**OLYMPIA DESIGN REVIEW BOARD  
RECOMMENDATION**

**CONCEPTUAL DESIGN REVIEW**

PROJECT NAME: Bayan Trails Multifamily PROJECT No.: 14-0139

PROJECT DESCRIPTION: Construction of multifamily development – four senior apartment buildings (168 units), ten townhome-style apartment buildings (70 units), community building, pool building, parking, pathways, raised garden beds, outdoor seating areas and viewing platform.

**SENIOR HOUSING | BUILDING A - FIRST FLOOR PLAN (BUILDINGS B, C & D SIMILAR)**

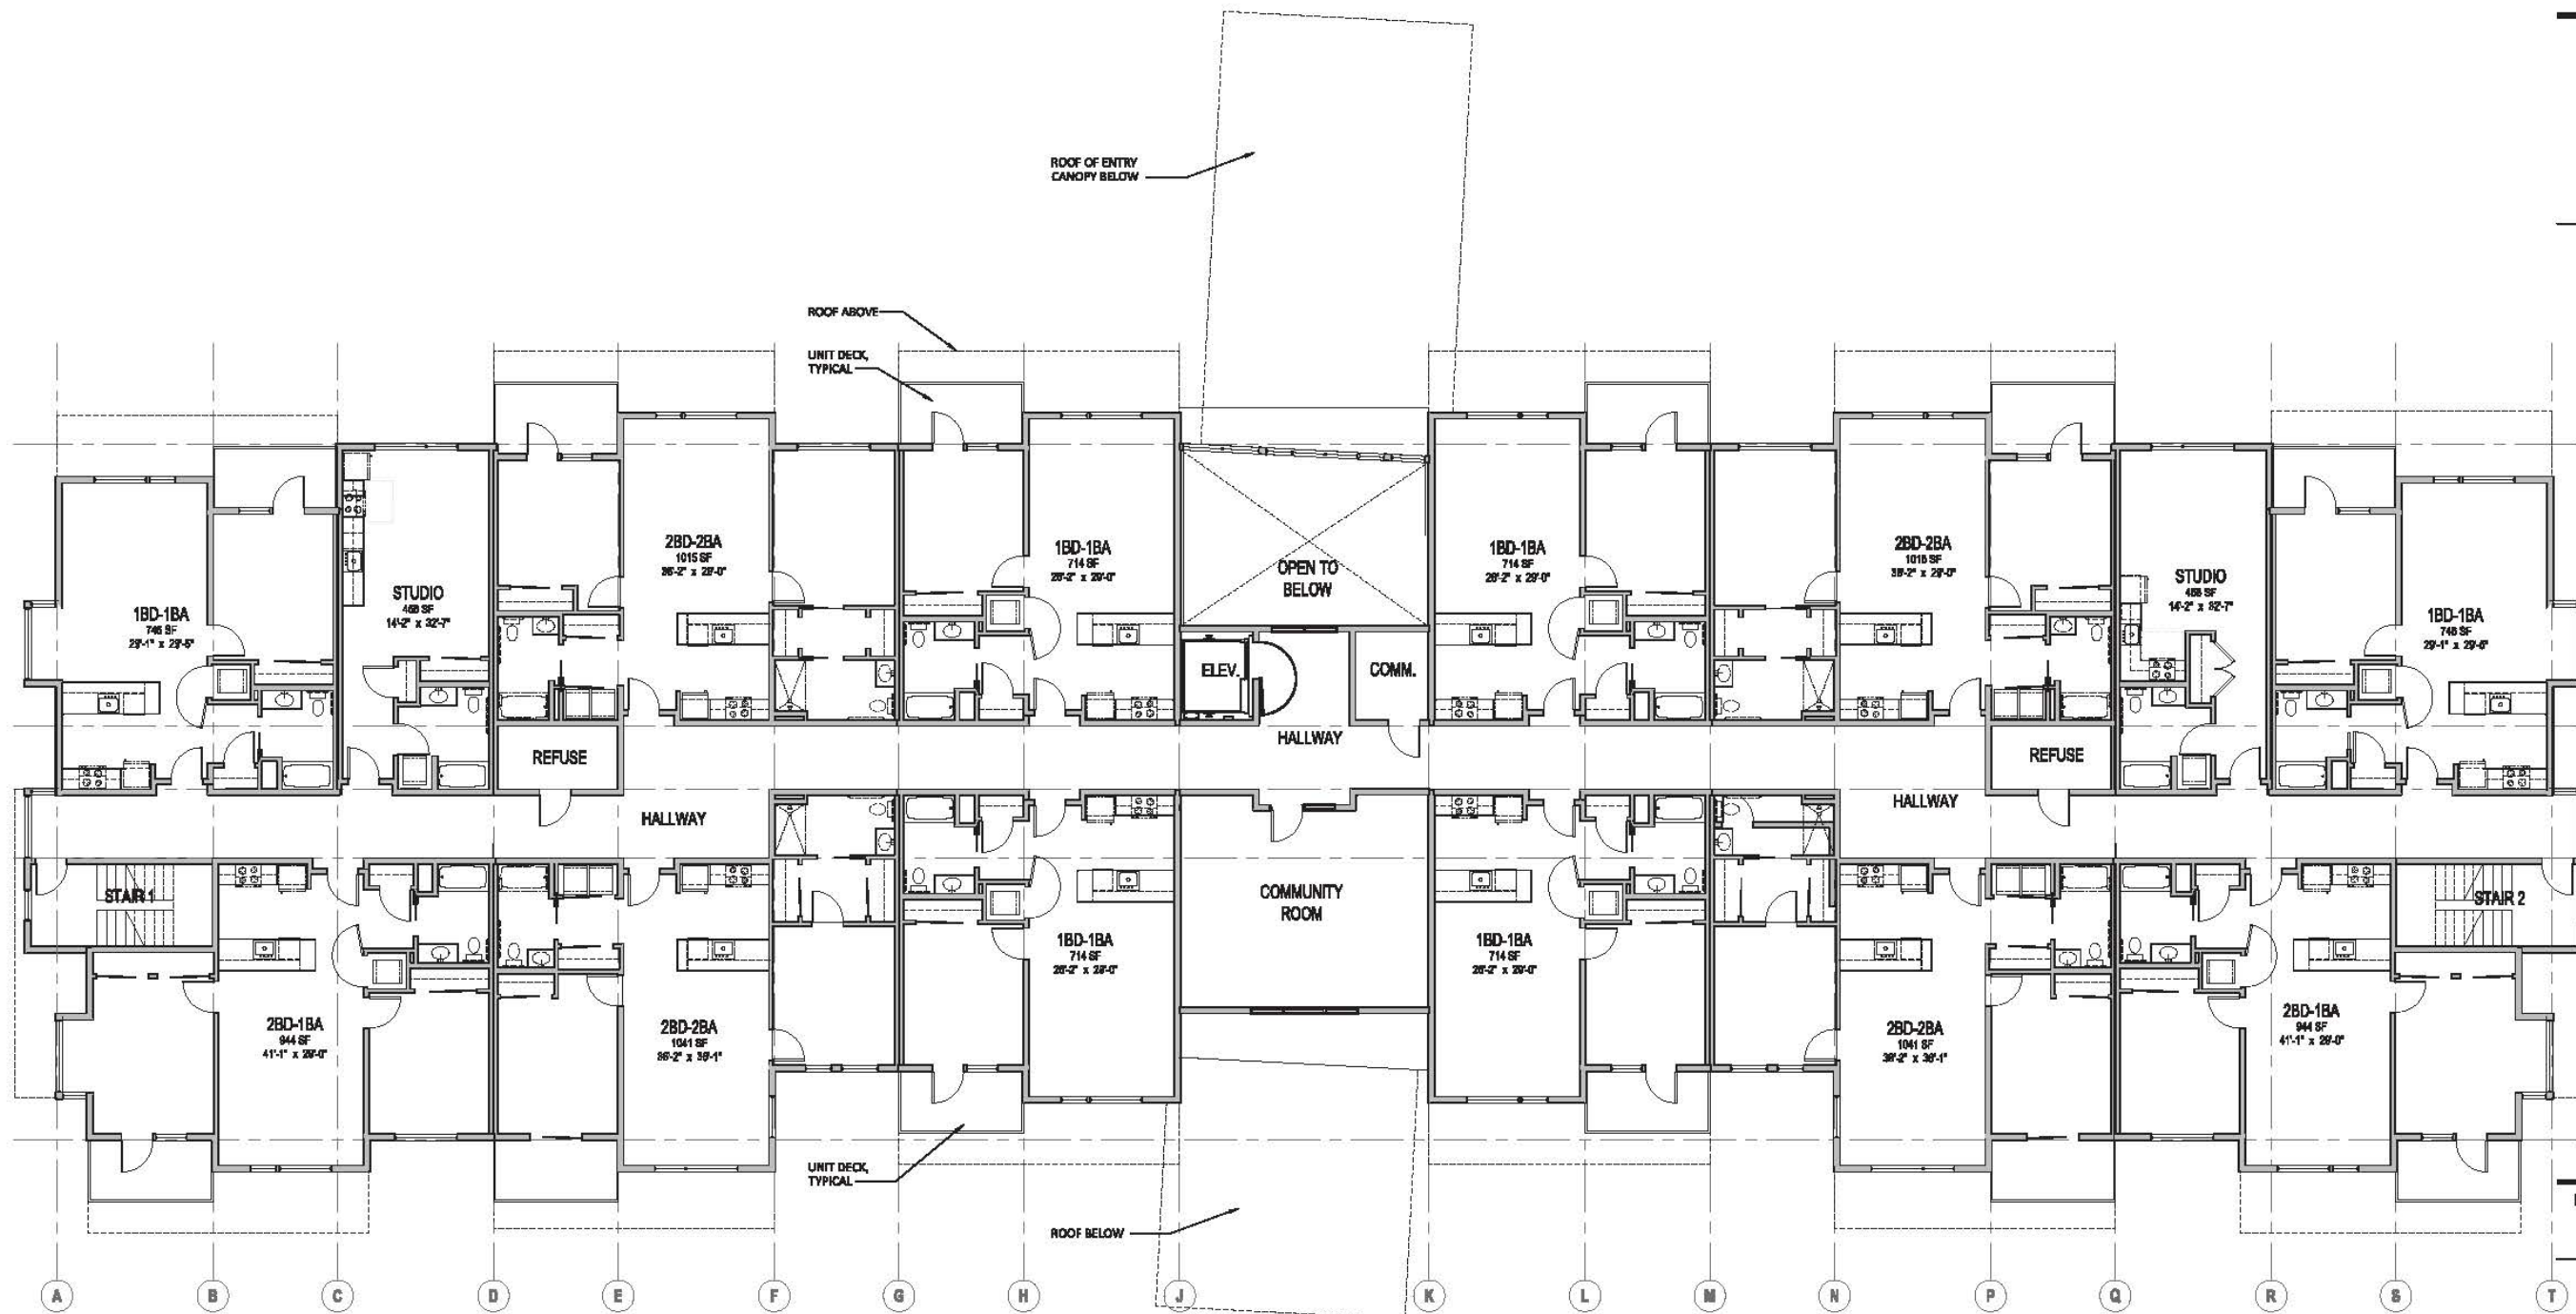
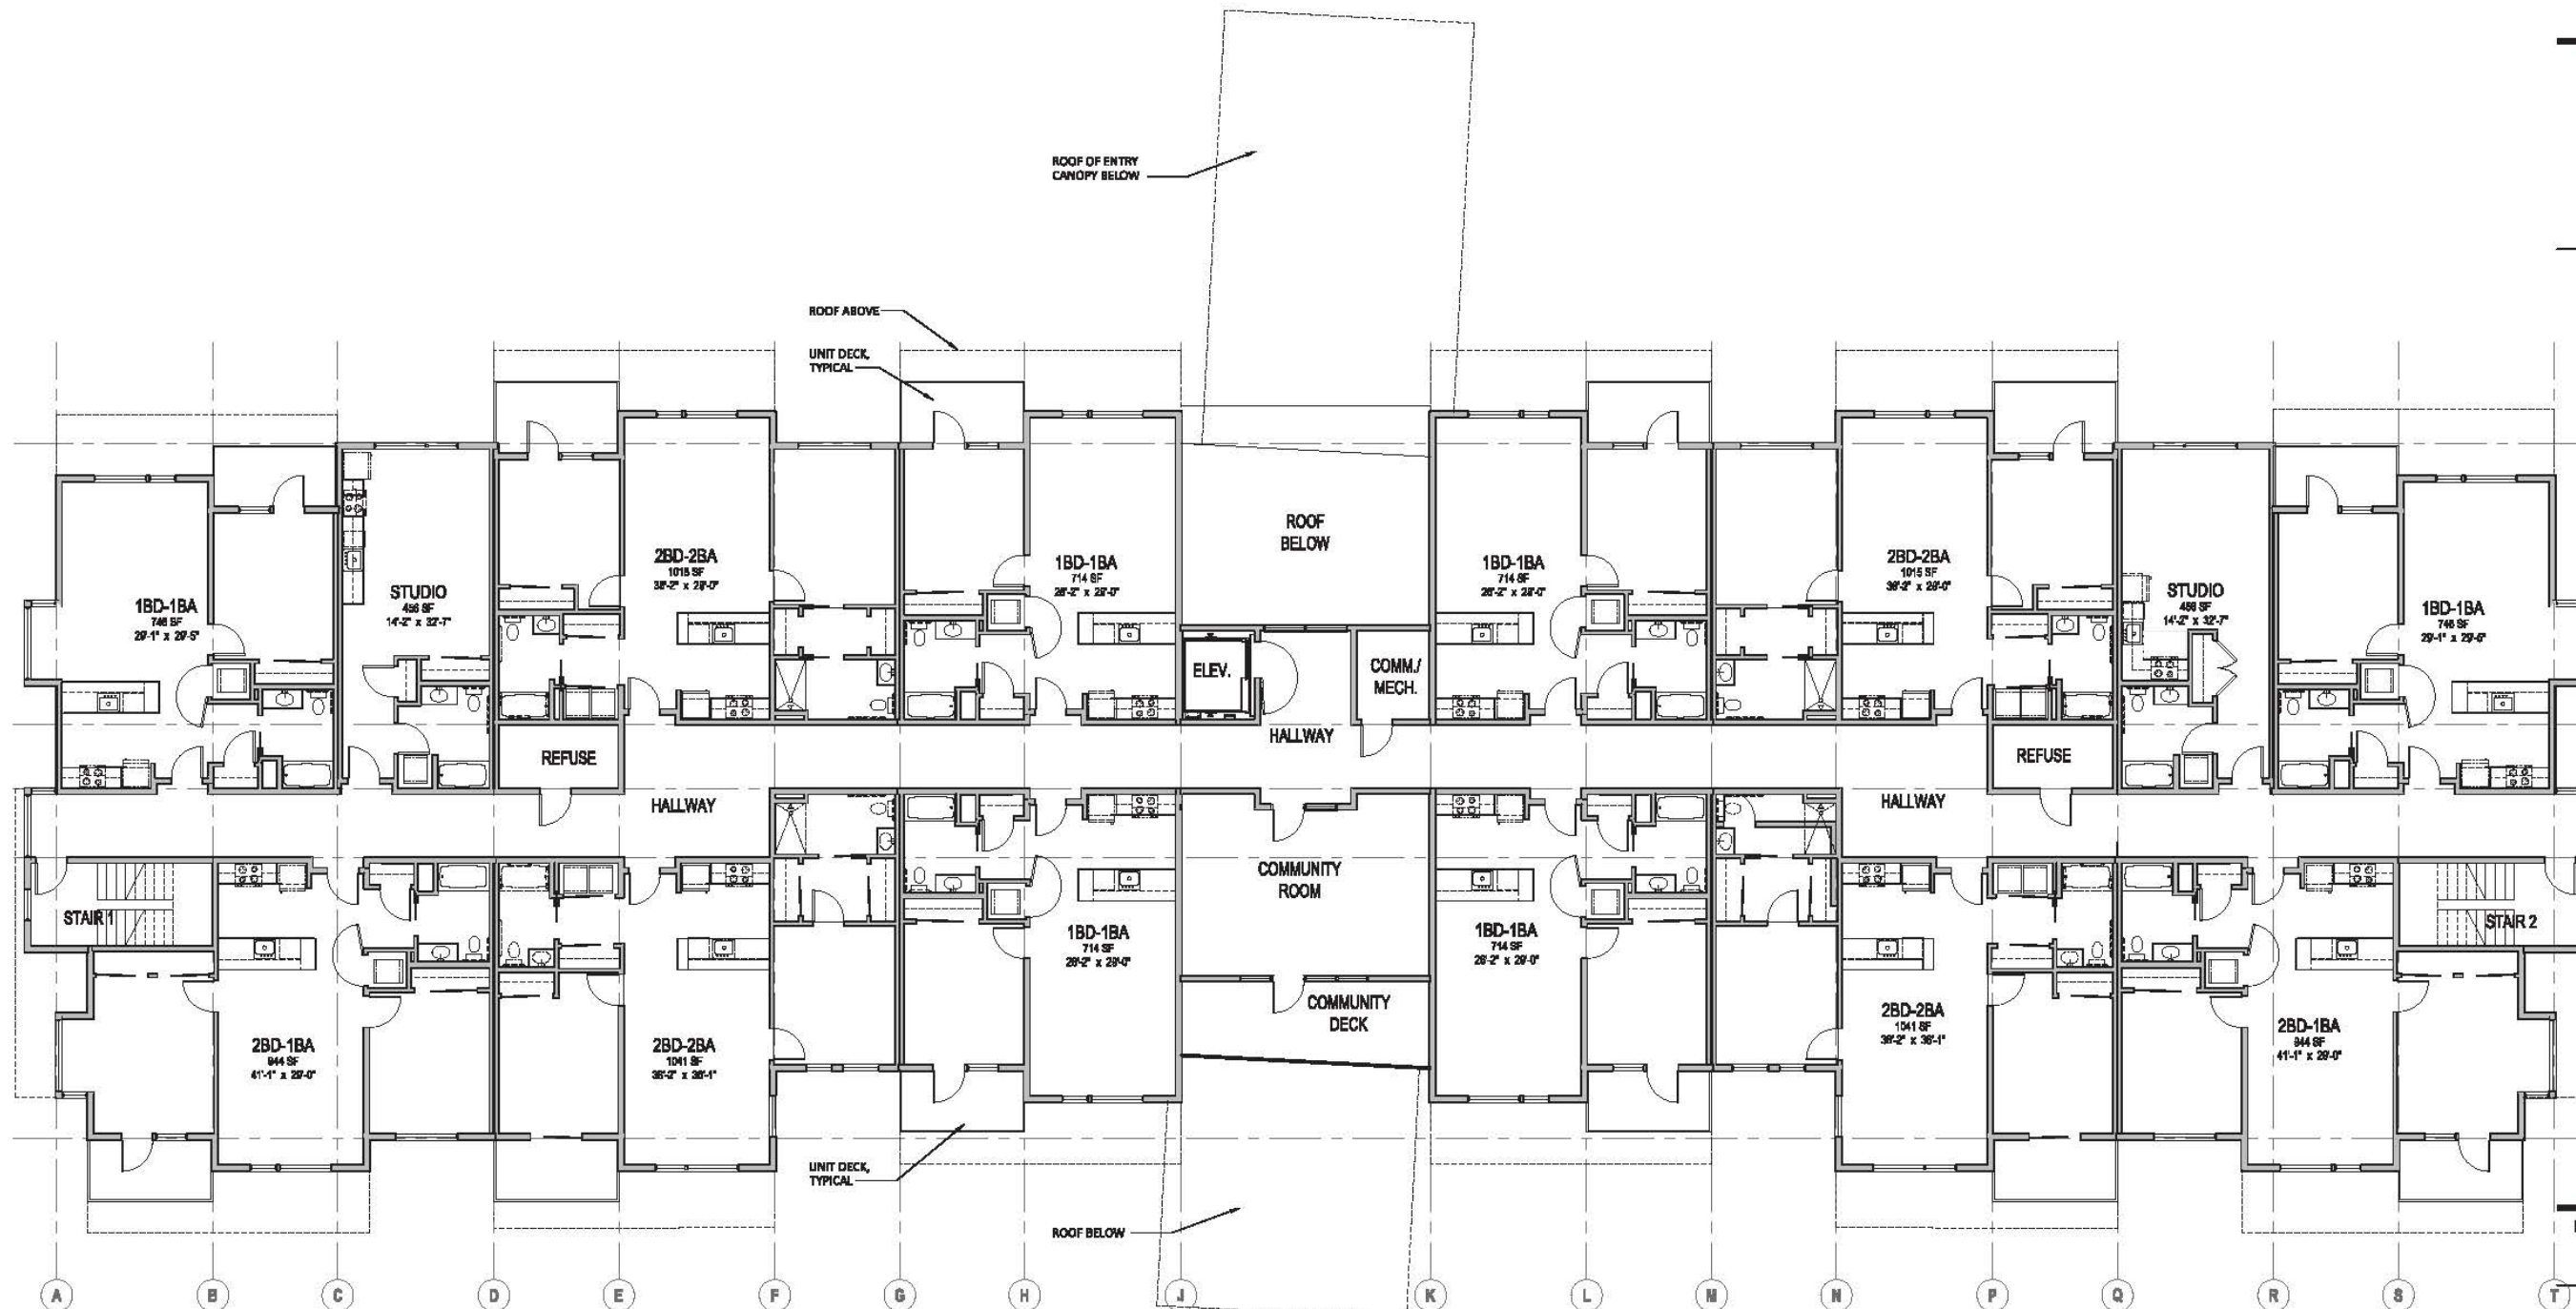
- 7) Windows, OMC 18.170.130 – Windows generally meet the design standards except in some locations where residents will be able to see into nearby units. Further study of window placement and floor plans is recommended.

- a) Move windows or adjust floor plans as needed to minimize opportunities for residents from one unit to look directly into other units. *18.170.130*
- b) Further study the use of materials and colors to better define the base, middle, and upper levels of the buildings. *18.170.140*
- c) Provide variation of material/color schemes throughout the project. *18.170.140*
- d) Modify the south elevations of the townhome buildings to improve neighborhood scale and character (see discussion above under Context Plan). *18.170.110*

SH - ELEVATIONS

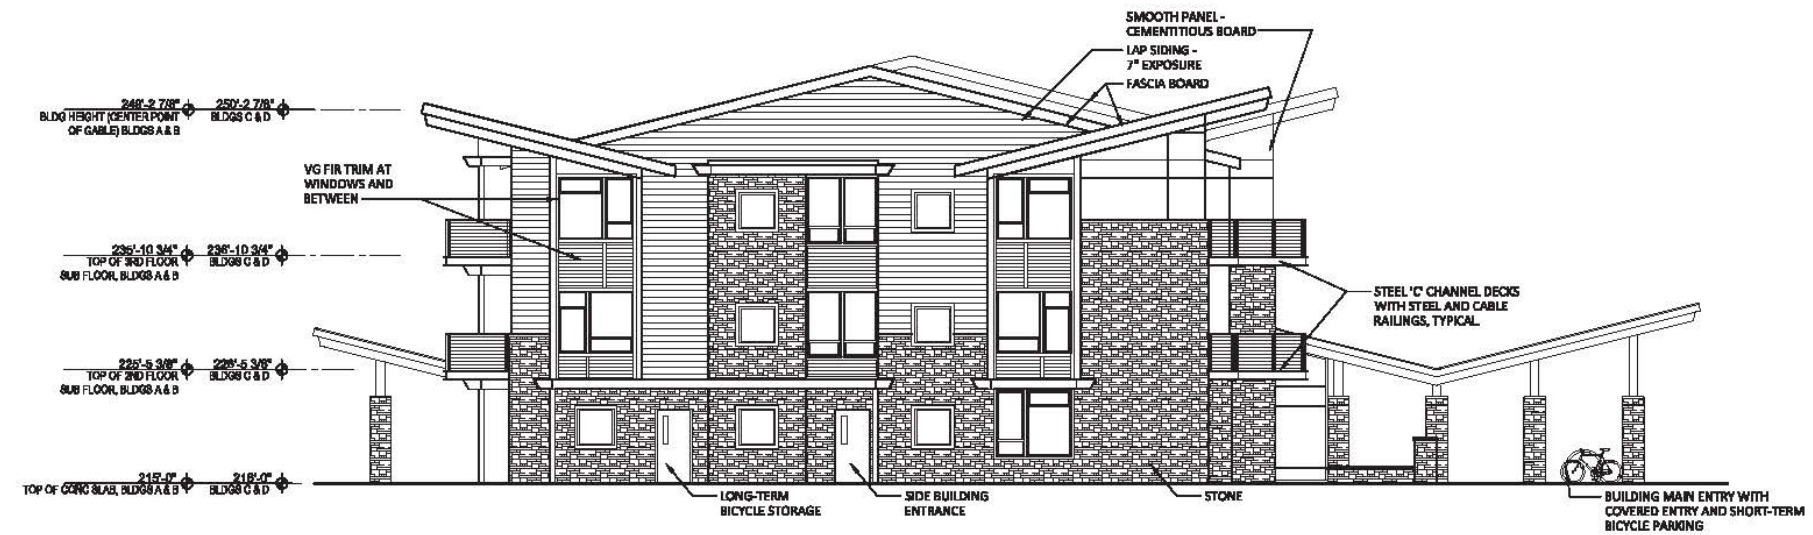
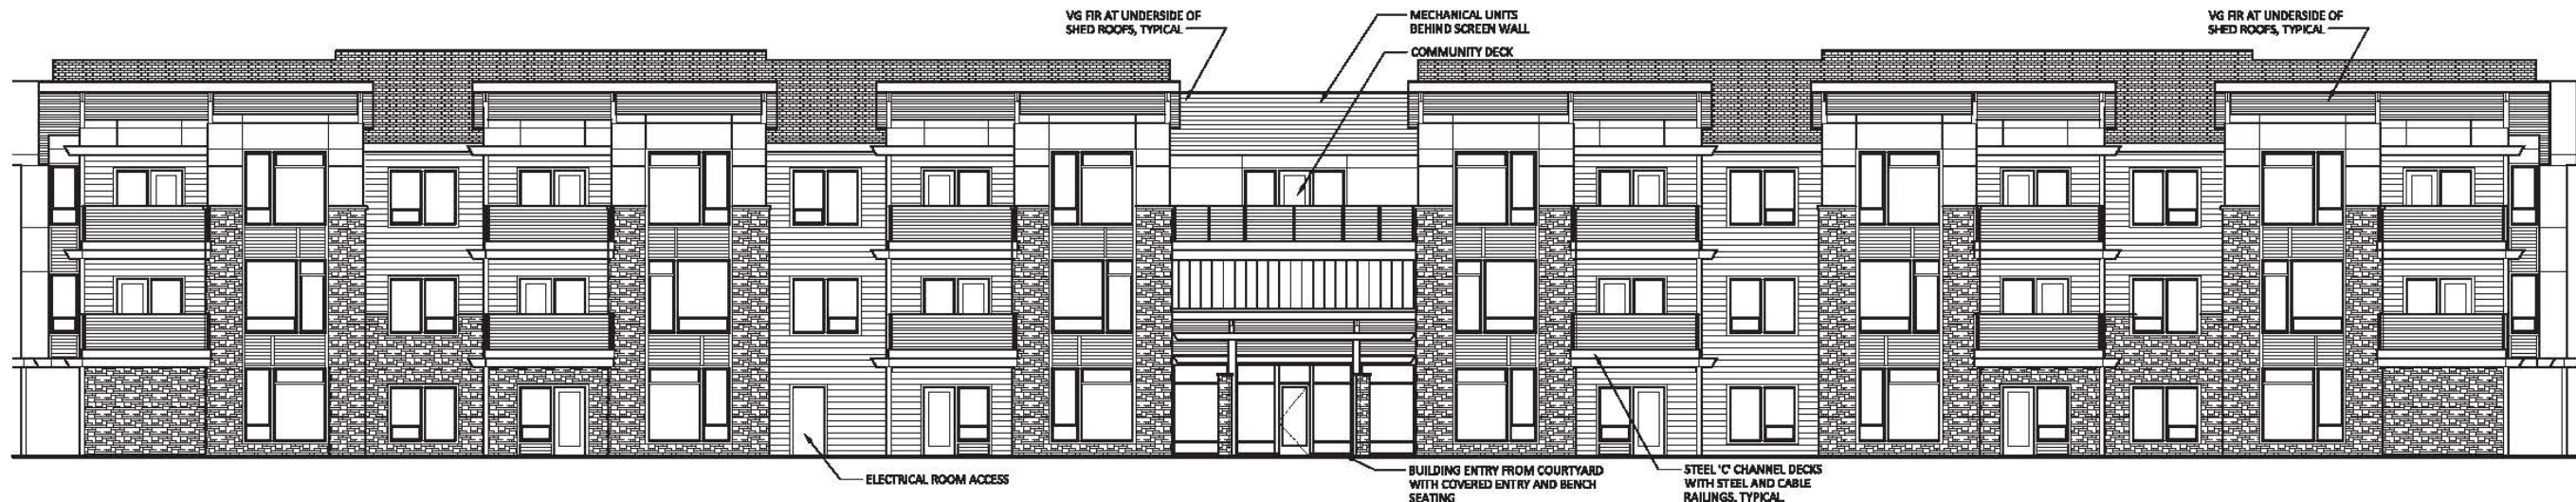
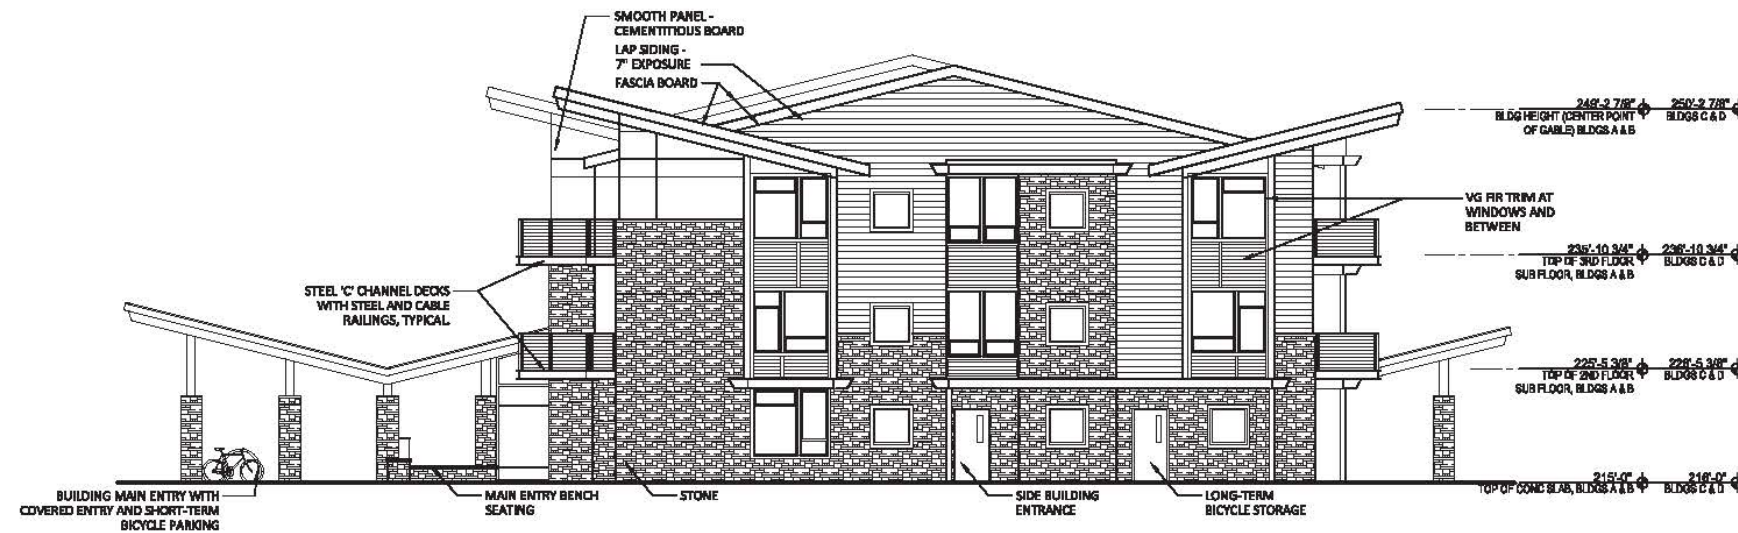
- 8) Materials/colors, OMC 18.170.140 – Use of materials generally meets this standard, but further study of both materials and colors is recommended to better differentiate between floors, define base/middle/upper levels, and provide variation between buildings.

- a) Increase the width of planting beds along the building foundations for increased screening of blank walls (e.g., on the east and west elevations of the senior apartments where the depth of the bed is approximately three feet).
